MEETING OF TOWN OF VERONA PLAN COMMISSION

Thursday February 15, 2024, 6:30 p.m.

3. Approval of Minutes from January 18th, 2024
4. Discussion and Possible Action: Land Use Application 2023-01 Sugar River Road Properties Concept Plan Review and Rezone

- a. Staff report
 - b. Applicant comments
 - c. Public comment
5. Discussion and Possible Action: Land Use Application 2024-02 Riverside Vista (062/0608-303-9000-8 east of 7906 Riverside Road) Preliminary Plat, Declaration of Covenants and Developer's Agreement

CONCEPTUAL PLAT
 TOWN OF VERONA, WISCONSIN

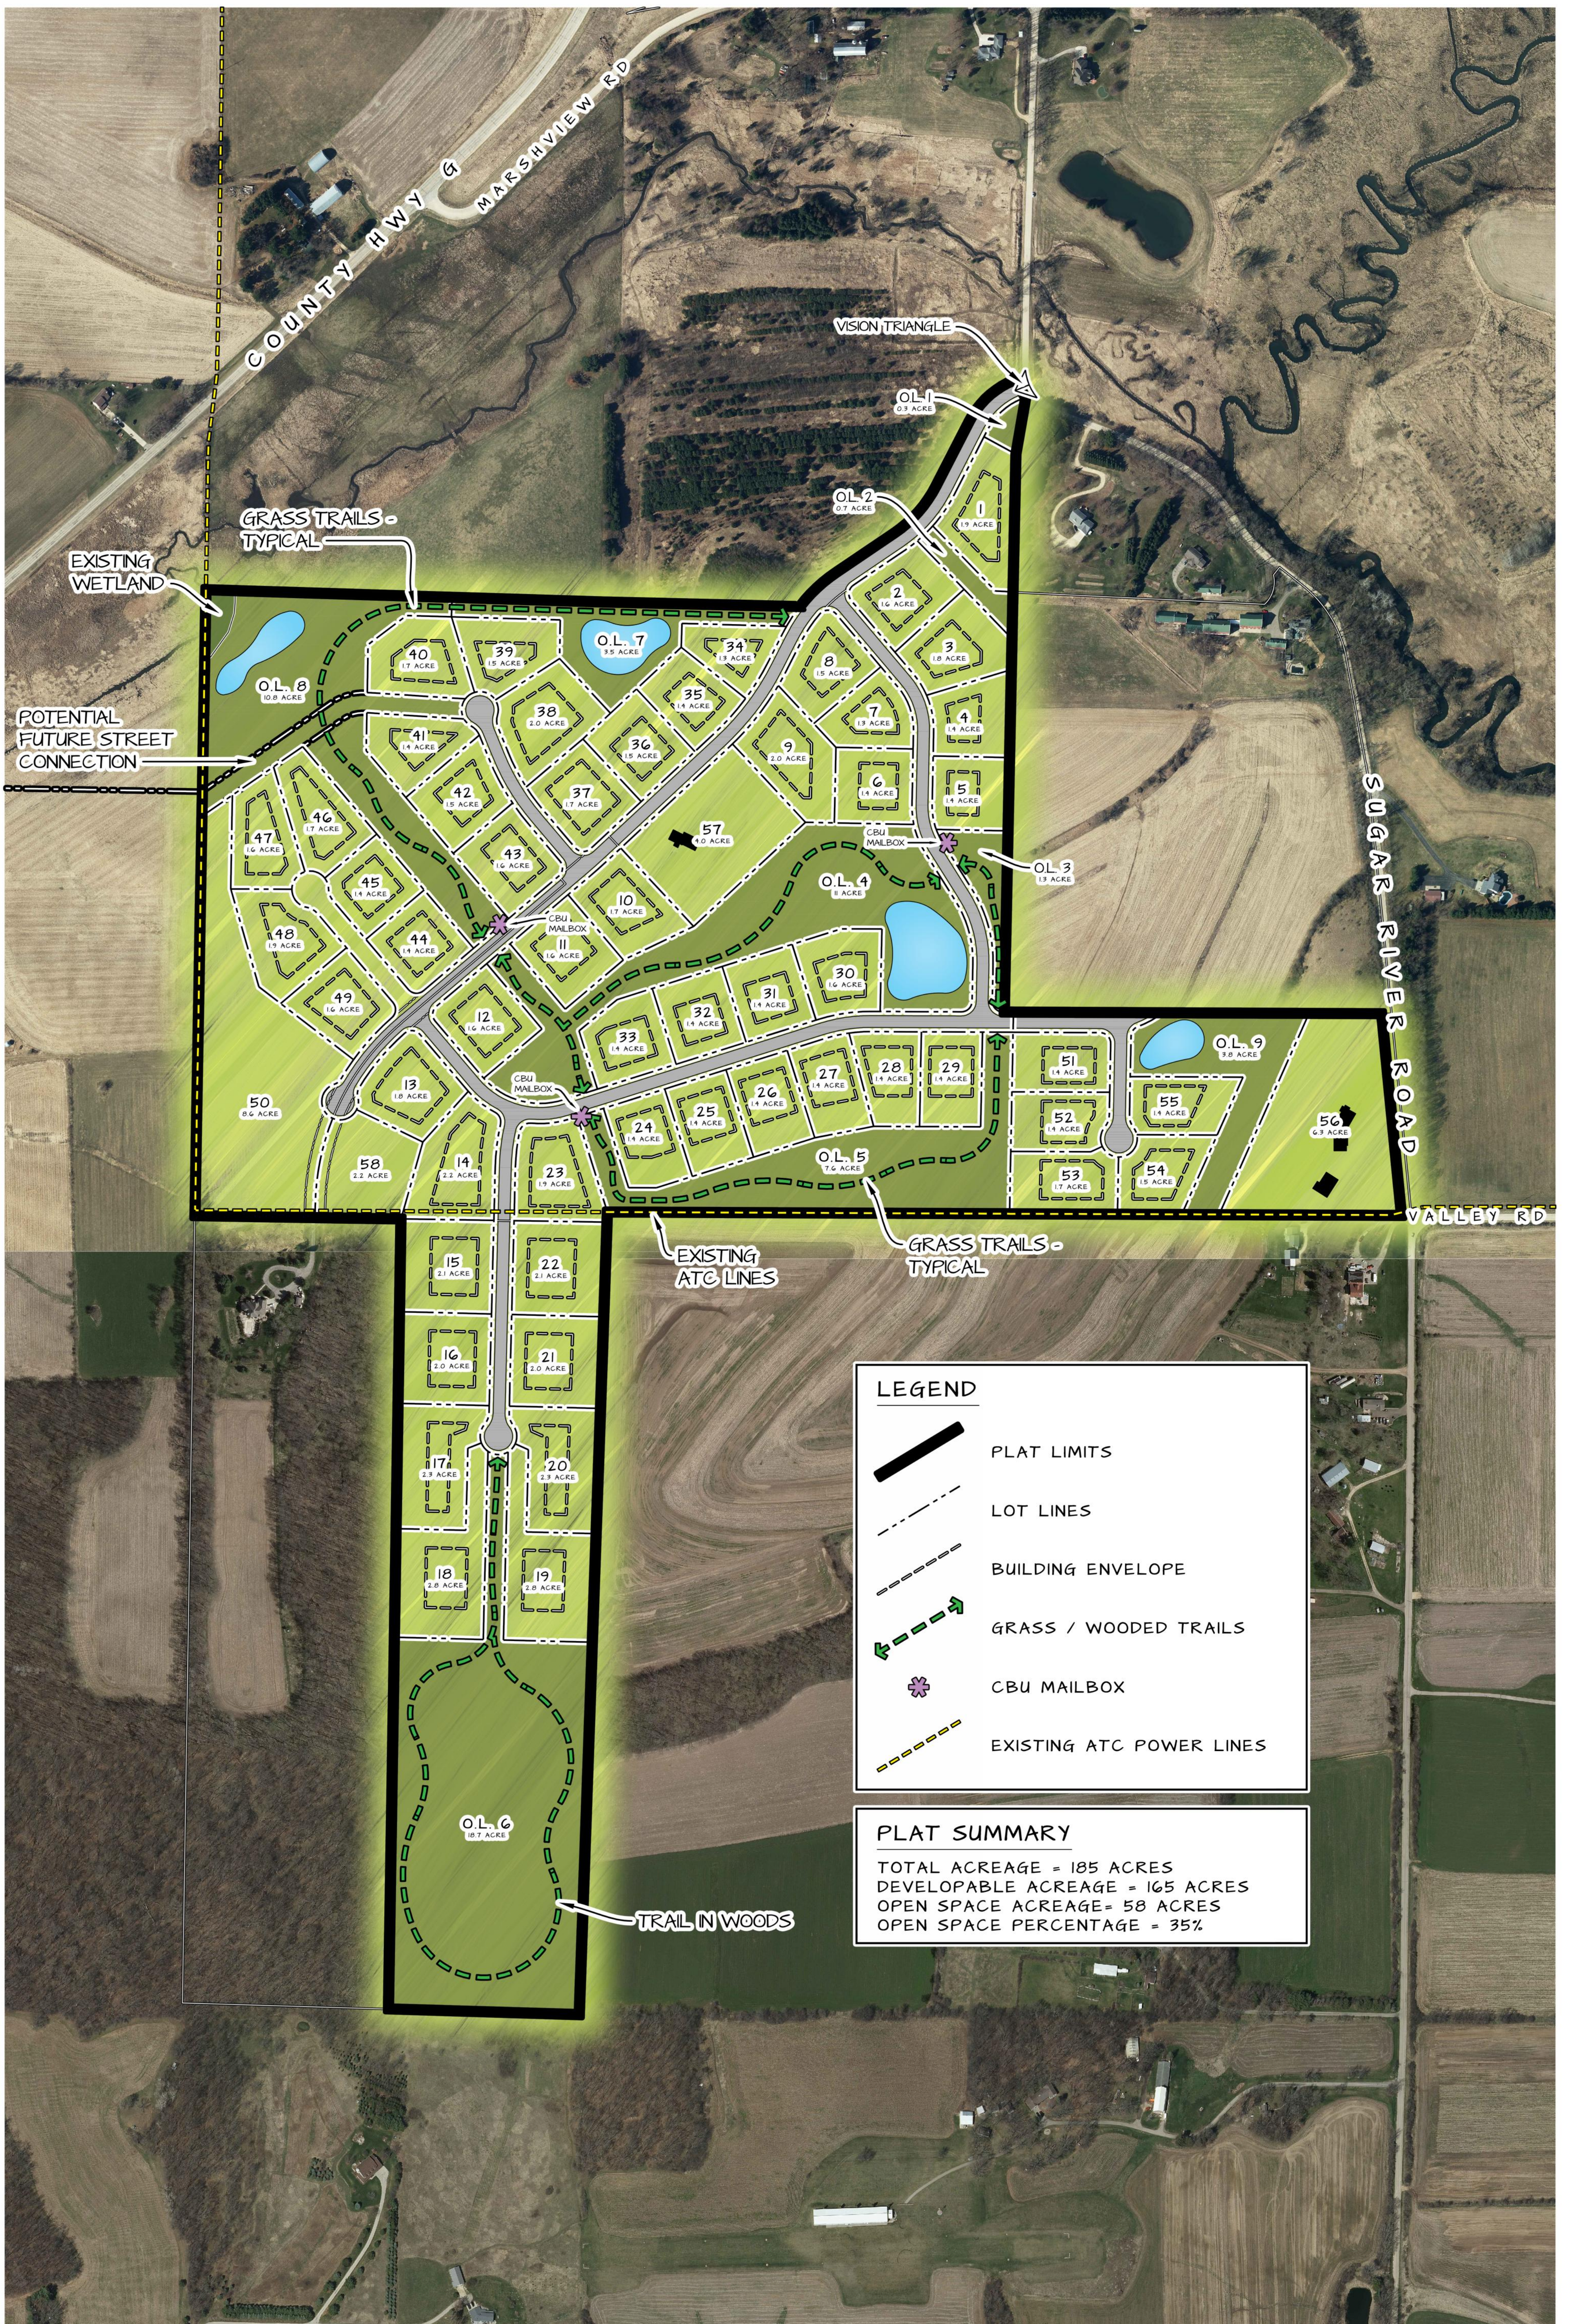
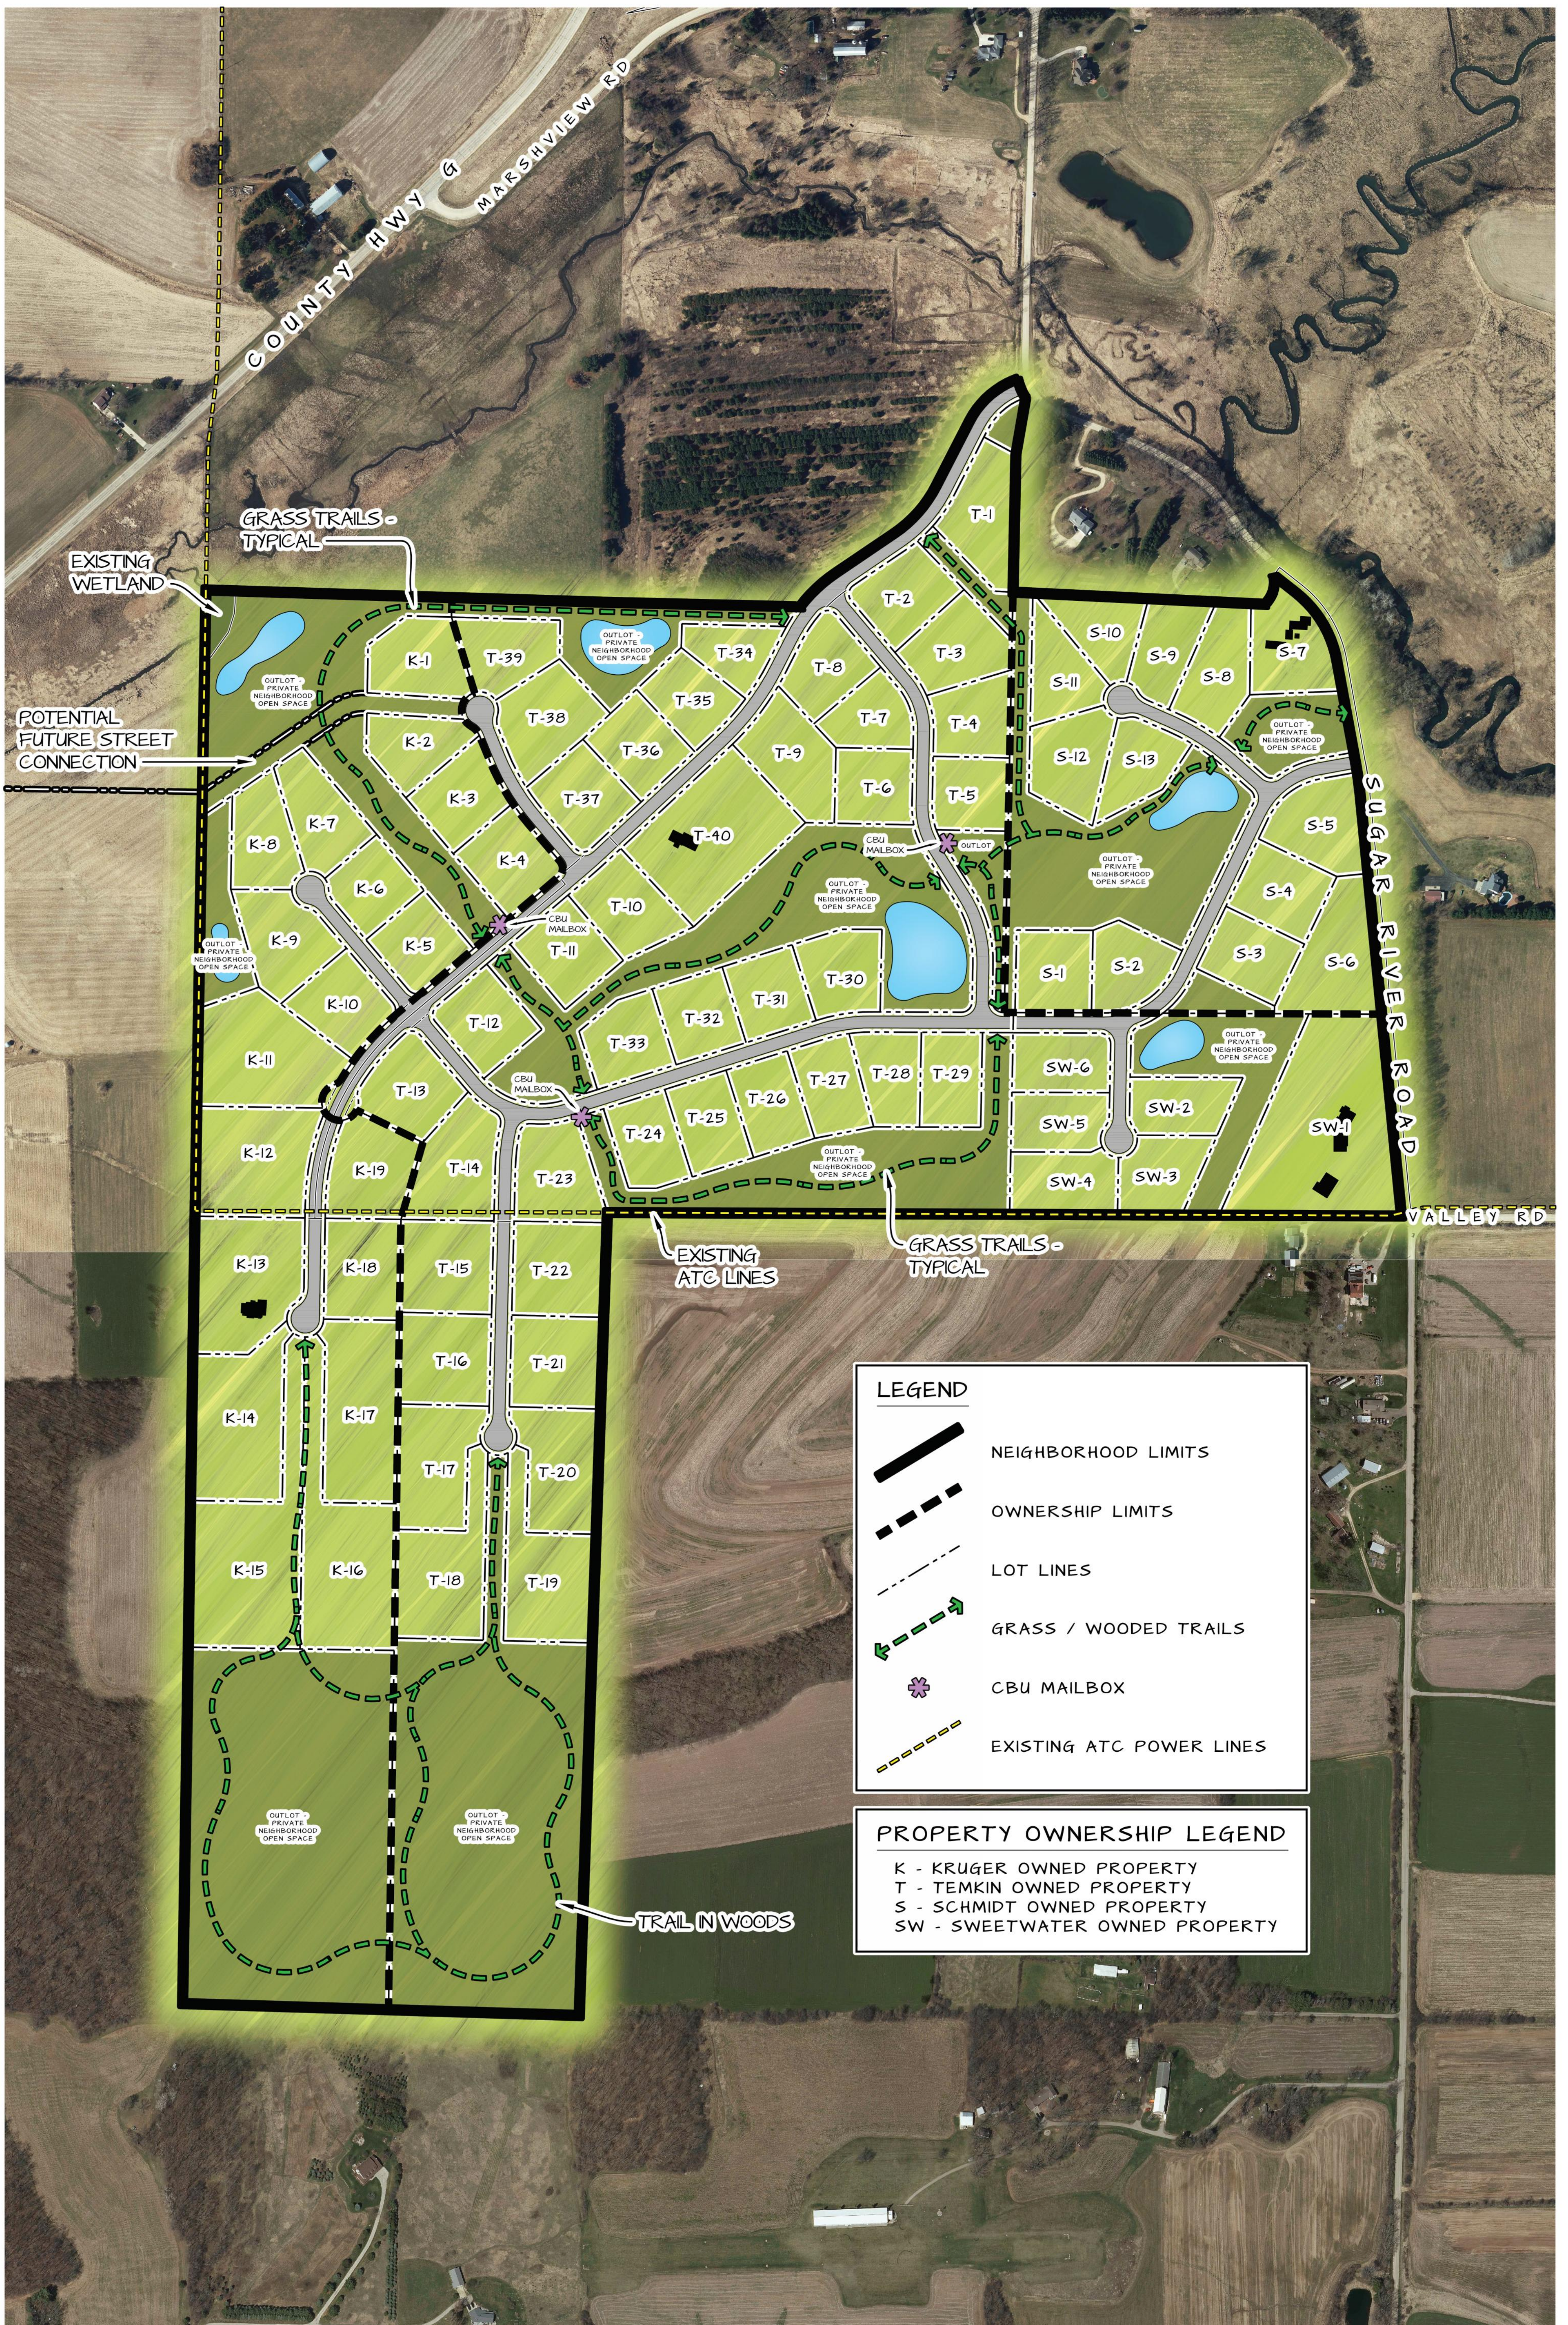
- Design speed of roads is preferred to be 25mph
- County documentation of manure management plan would be helpful
- Lots 19-22 may need to be shifted to accommodate 300' distance for well placement

- Phasing of road construction
- Mailbox locations should be examined to minimize inconvenience to current residents (location likely dictated by USPS)
- Better explanation of the methods employed in the Traffic Impact Analysis

- Application needs to include vision triangle, floodplain, slopes between 12 and 20%, existing wells and septic fields on the existing conditions map
- Generally supportive of the design
- Design changes made to date are favorable and reflective of the Comprehensive Plan
